The Children's Hospital at Westmead Paediatric Services Building

Architectural Design Statement - Addendum

State Significant Design Application No. **SSD-10349252**

Document Number: CHW-AR-DG-PSB-SSD081
November 2021

Figure 4-1: Study of Folded Metal Panels

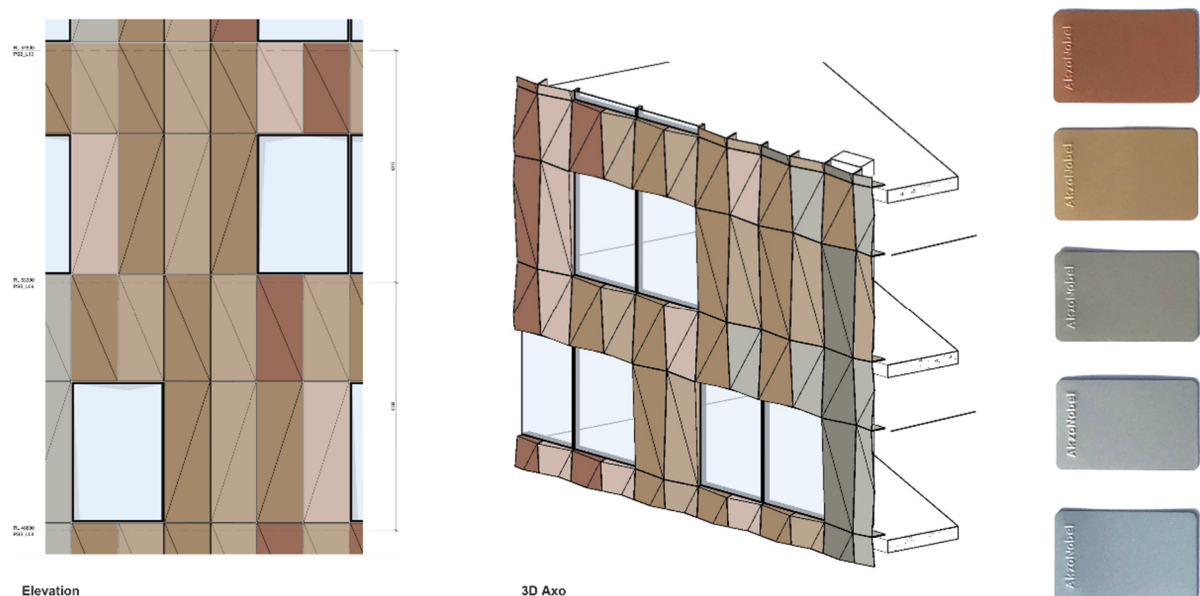
The façade will employ a series of shimmering metallic finishes, diagonally folded aluminium panels (inward and outward folding), to allow the light to bounce across the façade surfaces. This will create a dynamic and ever-changing materiality. At the end of each 'finger' are a series of winter gardens which will be clad in a series of glazed operable louvres to maximise distant views and access to fresh air.

Folded Panels will be arranged in an overall organised palette to create a macro folded/ ripple pattern across the façade. The folds will thus be visible both at close range and from a distance. The folded panels will create distinct shadow effects which will change throughout the day with the movement of the sun, reflecting changes in the sky, as water reflects changes in the sky.

Figure 4-2: Indicative Materials and Colour Selections

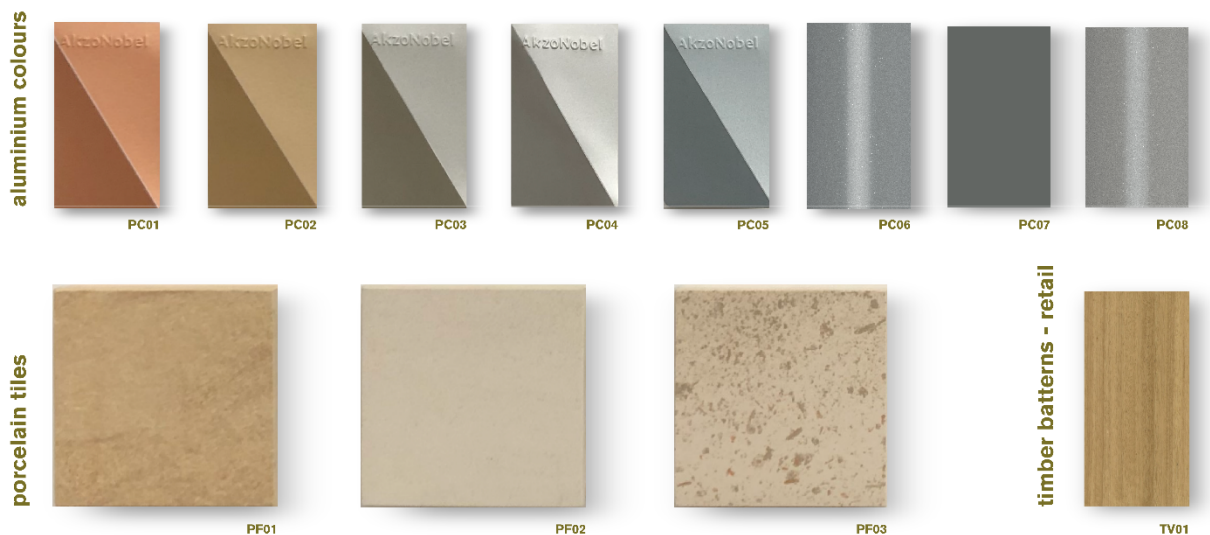
A warm colour palette of varying textures and natural finish mimics the textures of pebbles found along the river's edge – adding texture and detail where people will experience the façade. Openings within the facade are conceived as an abstracted pattern of punched rear glazed units accentuating the solidity of this form.

Riverbanks and edges are eroded by the movement of water, exposing linear stratification of the underlying geology. The podium façade design will be based on this concept. Windows in the podium will be set back with deeper reveals, alluding to openings in rock faces. The use of ceramic tile will be further enhanced through the use of colour variation and its arrangement into a macro pattern, representing the geological stratification.

Figure 4-4: Southeast Elevation (KR Lane)

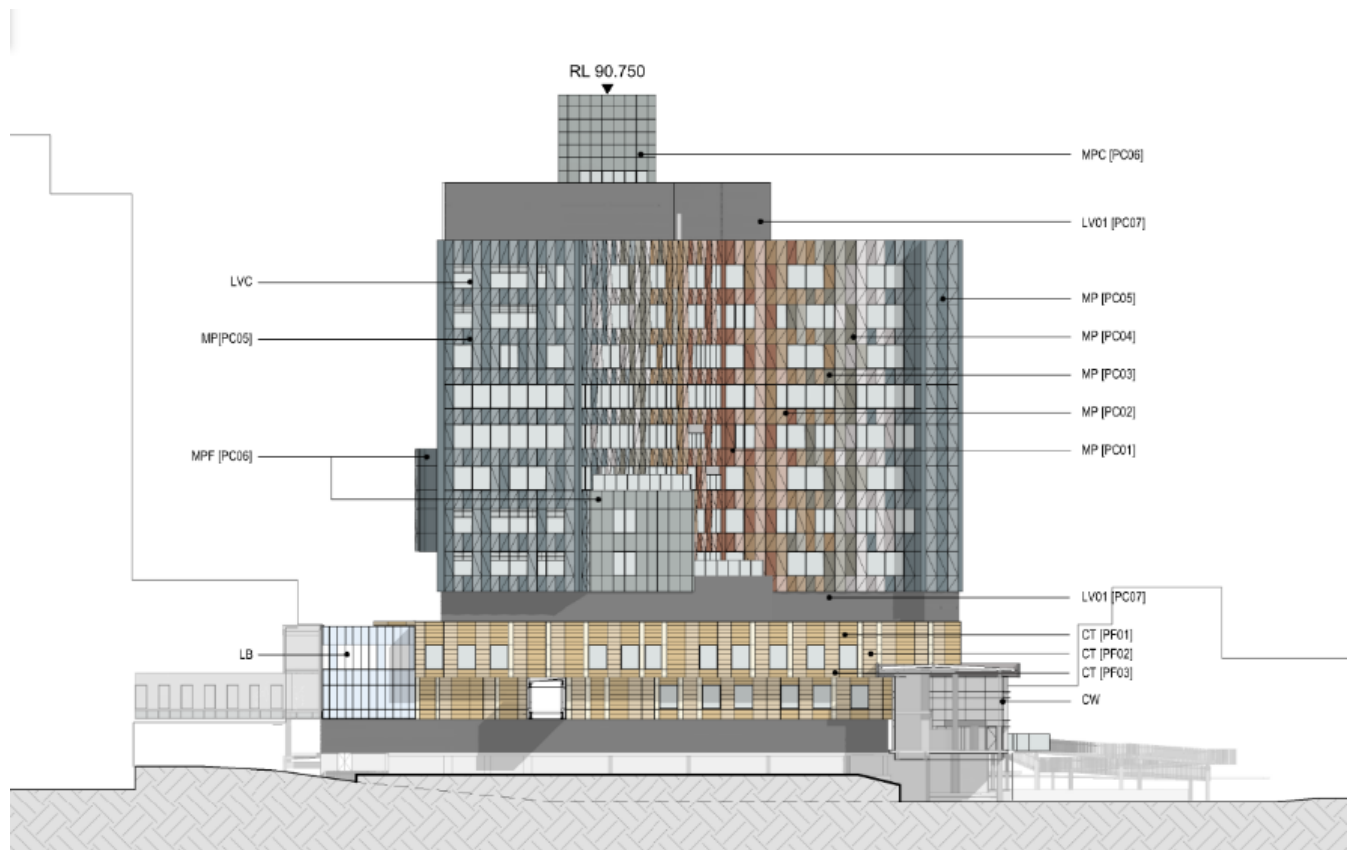
The overall number of façade types is minimised for clarity and construction efficiencies. Key façade types retain flexibility within the system to further articulate facades and adjust for internal planning changes. The amended façade types are listed below:
